Access Compliance Report

Public Rights-of-Way

(Curb Ramps)

Intersection ID: 14340	Main Street: KENILWORTH_AV	Cross Street: GREENWOOD_CLIFF	Location: S
ADA ID: 2FA19DDE6721	Ramp Type: PerpDiag	Initial Pass/Fail: Fail	Overall Compliance: No
		Severity Score: 30

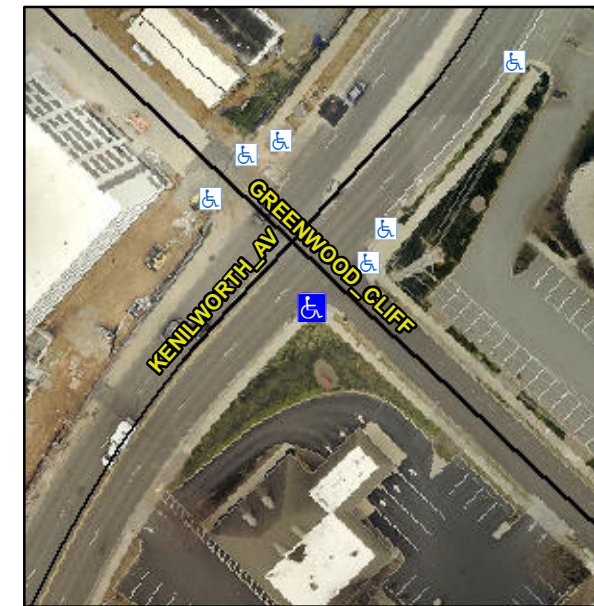
Not Found, R304.5.1, R304.5.3

Compliance	Description	Data	Compliance	Description	Data
N/A	Ramp Length (in)	64.0	Yes	Ramp Slope (%)	7.1
No	Ramp Width (in)	32.0	No	Ramp XSlope (%)	5.2
N/A	Flare Type LT	N/A	N/A	Flare Type RT	N/A
N/A	Flare Slope LT (%)	N/A	N/A	Flare Slope RT (%)	N/A
N/A	Flare Traversable LT?	N/A	N/A	Flare Traversable RT?	N/A
N/A	Landing Length (in)	N/A	N/A	DWS Provided?	N/A
N/A	Landing Width (in)	N/A	N/A	DWS Contrast?	N/A
N/A	Landing Slope (%)	N/A	N/A	DWS Length (in)	N/A
N/A	Landing X Slope (%)	N/A	N/A	DWS Full Width?	N/A
N/A	Landing Curb? (Y/N)	N/A	N/A	DWS Offset (in)	N/A
N/A	Shared Landing?	N/A			
N/A	Gutter Ponding?	N/A	N/A	Gutter Slope (%)	N/A
N/A	Gutter Lip Ht (in)	N/A	N/A	Gutter X Slope (%)	N/A
N/A	Painted X Walk1?	No	N/A	Painted X Walk2?	No
	X Walk 1 Direction	To NE		X Walk 2 Direction	To NW
N/A	X Walk 1 Width (in)	N/A	N/A	X Walk 2 Width (in)	N/A
	X Walk 1 Slope (%)	0.2		X Walk 2 Slope (%)	2.2
	X Walk 1 X Slope (%)	6.1		X Walk 2 X Slope (%)	1.4

Remove & Replace Curb Ramp With Two New Directional Ramps or Equivalent.
